B-048 October 11, 2002

SAFETY RECALL CODE 0825 - SIDESTAND LEG FOR 2003 FIREBOLT XB9R

Figure 1. Correct Sidestand with Footpad Stamped

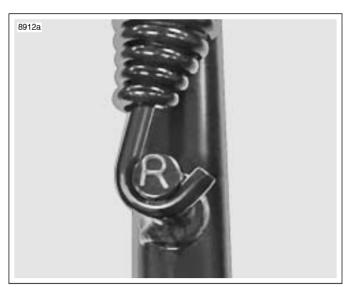
See Figure 1. The correct replacement sidestand, for the purpose of this bulletin, is: Part No. 94129Y. It can be identified by the Letter "R" stamped on either the sidestand footpad or on the sidestand leg pin. See Figure 2.

Figure 3. Sidestand Assembly

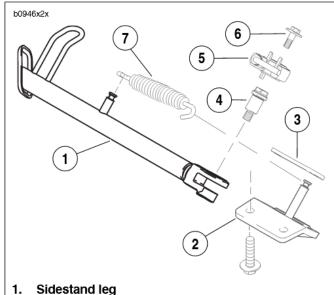
- c. See Figure 3. Install sidestand (1) and sidestand pivot bolt (4) tightening to 18-20 ft-lbs (24-27 Nm).
- d. Retract sidestand leg.
- Install spring extension plate (3) and sidestand spring (7) using SNAP-ON SPRING TOOL (Part No. HE-52B).

- Install sidestand switch (5).
 - Extend sidestand leg.
 - Install sidestand switch by aligning the lug on the bottom side of the switch with the corresponding hole in the sidestand leg.
 - Install the switch fastener (6) tightening to 36-60 in-**Ibs** (4-7 Nm).
- Apply LOCTITE 272 (Red) to the two fasteners for left side of chin fairing and install. Tighten to 36-48 in-lbs (4-5.4 Nm).

Figure 5. Threaded Area for Loctite Application

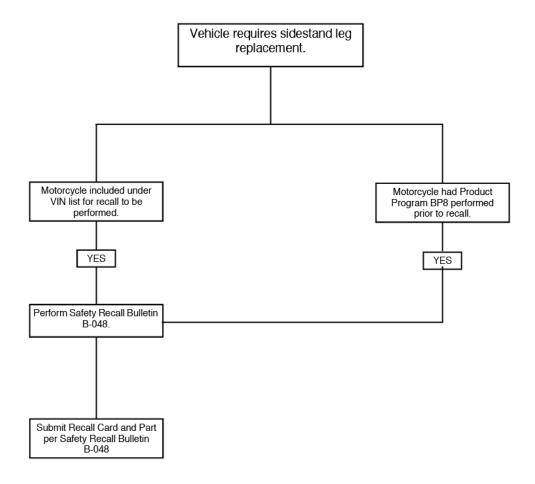
- 1. Install sidestand leg (1).
 - a. See Figure 4. Lubricate sidestand pivot bolt and mating portions on sidestand bracket with WHEEL BEARING GREASE (Part No. 99855-89).
 - See Figure 5. Apply LOCTITE 272 (Red) to threaded area (clevis) of sidestand leg.

Applying LOCTITE to threaded area of clevis on sidestand leg, instead of threads on the pivot bolt, will eliminate build-up between clevis and sidestand bracket which can interfere with the applied lubricant.
